## STAFF REPORT

**Date:** September 12, 2017  
**To:** Bryan H. Montgomery, City Manager  
**From:** Kenneth W. Strelo, Senior Planner  
**SUBJECT:** McDonald's Renovation Design Review (DR 07-17)

This is an application by McDonald's USA (Tom Clark) and Stantec Architecture (Zorah Mariano) ("Applicant") requesting Design Review approval for McDonald's restaurant to do a façade remodel (including mansard removal, entry tower modifications, and new paint, trellis, and signage), and conversion of the single lane drive-thru into a side-by-side drive-thru. Other site modifications include relocation of the trash enclosure, removal of three parking stalls, and making ADA site improvements. The project is located at [914 Main Street](#) and zoned C (General Commercial) District. APN 051-052-062.

Figure 1. Existing and Proposed Front Elevation

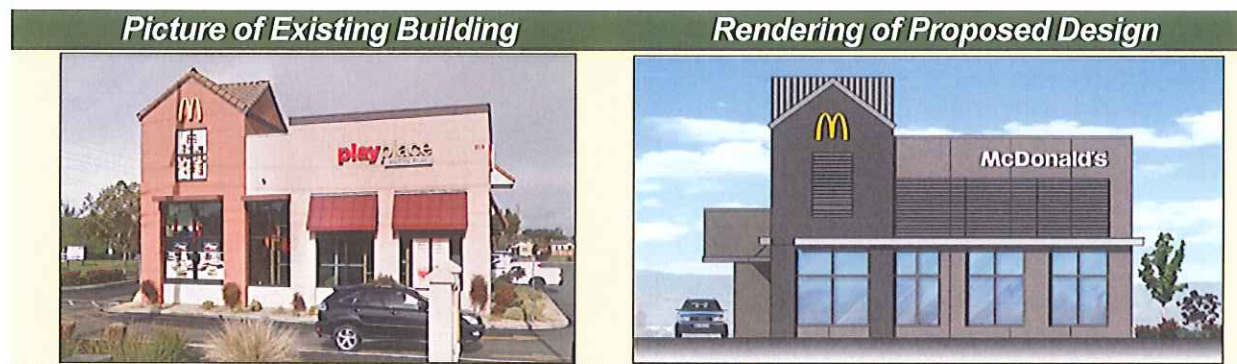
The main difference between the existing building and proposed building is the color change. The updated grey tones will still bring attention to the tower element, and also create more contrast with the trim and signage. The proposed colors will create a cleaner appearance to the building. Stucco will remain the main exterior material; however, the proposed design will include large metal trellises on the upper portions of the exterior walls for added architectural interest. Also, the existing window canopies that cover a portion of the upper windows will be replaced with a horizontal window overhang. This will result in opening up the façade while maintaining some relief from high sun period of the day. Finally, the roof material will be switched from concrete tile to standing seam metal. The latter will blend better with the grey color scheme and metal trellises.

Figure 2. Proposed Site Plan

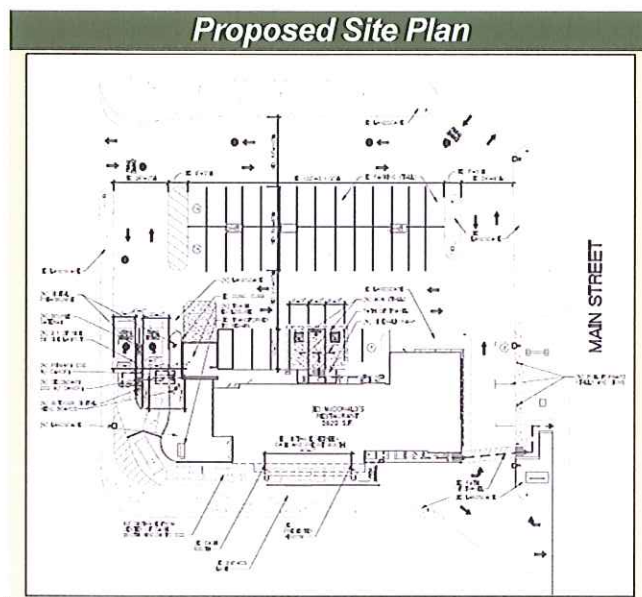
vehicles, and restriping some of the parking near the building entrance that will be impacted by the design changes. The redesign will also include a reduction of 3 parking spaces (40 to 37), but will retain the same number of ADA spaces (2 with 1 van accessible), and will convert two standard spaces to compact spaces. Figure 2 shows the proposed site plan.

As stated in the project description, the site modifications will cause the loss of three parking spaces, resulting in a total of 37 off-street parking spaces. Oakley Municipal Code section 9.1.1402 "Off-Street Parking" includes a table of minimum off-street parking spaces specific to certain land uses. "Eating and Drinking Establishments" are required to provide one (1) parking space for each 150 square feet of net public use. The McDonald's restaurant is approximately 5,620 square feet in total. When using the entire building area to calculate the required parking spaces, a total of 37 spaces would be required (37.47 rounded down); however, several areas of the building would not be included in the "net public use" area. Therefore, the actual number of required spaces is less than 37.

8. The two proposed compact spaces shall allow for a minimum of one foot of overhang to meet the minimum length of 16 feet per Oakley Municipal Code ("OMC") section 9.1402(f)(1).
9. All menu boards and directional signs shall comply with the applicable requirements of the Oakley Sign Ordinance (OMC Chapter 9.5).
10. The proposed trash enclosure shall implement any applicable National Pollutant Discharge Elimination System ("NPDES") requirements for stormwater drainage.
